CITY OF FONTANA

I-15 LOGISTICS

FINAL ENVIRONMENTAL IMPACT REPORT

Section 2.0 Responses to Comments

Figure 1: South Coast AQMD Staff's Screenshot of Proposed Project's Line-Volume Truck Emission Sources in AERMOD

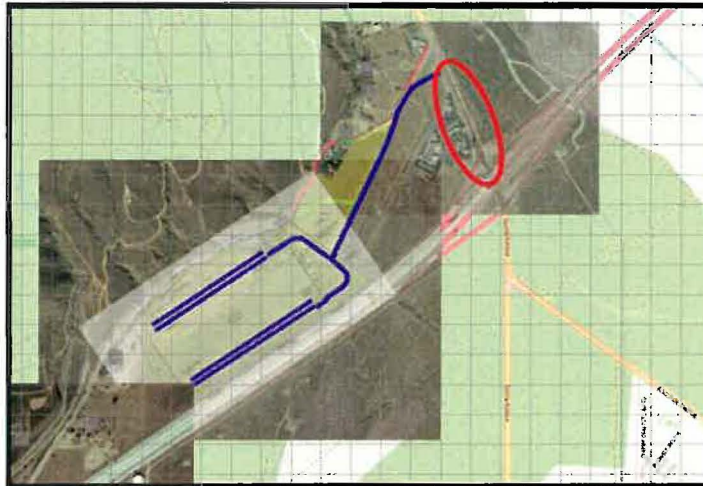
2. The Lead Agency used AERMOD to model the dispersion of the Proposed Project's emissions and perform a health risk assessment (HRA). In AERMOD, the Lead Agency modeled the dispersion of diesel particulate matter (DPM) emissions from heavy-duty trucks entering and exiting the Proposed Project, onsite travel, and trucks idling at the proposed dock doors. As illustrated in Figure 1, trucks entering and exiting the Proposed Project were modeled as a line-volume source from the Proposed Project's boundary to Sierra Avenue. However, it is recommended that mobile source emissions resulting from heavy-duty trucks visiting the Proposed Project be modeled to the nearest freeway on-/off-ramp. Therefore, South Coast AQMD staff recommends that the Lead Agency revise the air dispersion modeling to account for trucks traveling to and from the nearest freeway, in this case Interstate 15 (circled in red in Figure 1).

- 3-7 The commenter requests that the dispersion modeling and health risk assessment modeling be updated to include air dispersion modeling to and from the nearest freeway. The air dispersion modeling and health risk assessment (HRA) has been revised to include a line-volume source along Sierra Avenue to the nearest Interstate 15 (I-15) on-/off ramp. This addition allows the modeling to account for trucks traveling to and from the nearest freeway, I-15 in this case. This change is reflected in *I-15 Logistics Center Alternative – Health Risk Assessment Technical Memo* (HRA Memo), prepared by Michael Baker International, dated March 25, 2020; refer to Section 3.0. As concluded on Page 7 of the *I-15 Logistics Center Alternative – Health Risk Assessment Technical Memo* (HRA Memo) non-carcinogenic hazards resulting from the Proposed Project are calculated to be within acceptable limits; refer to Appendix B, of the Final EIR. Additionally, impacts related to cancer risk and PM₁₀ concentrations from warehouse operations would be less than significant at the nearest residential receptors and for workers. Therefore, impacts related to health risk from warehouse operations would be less than significant.
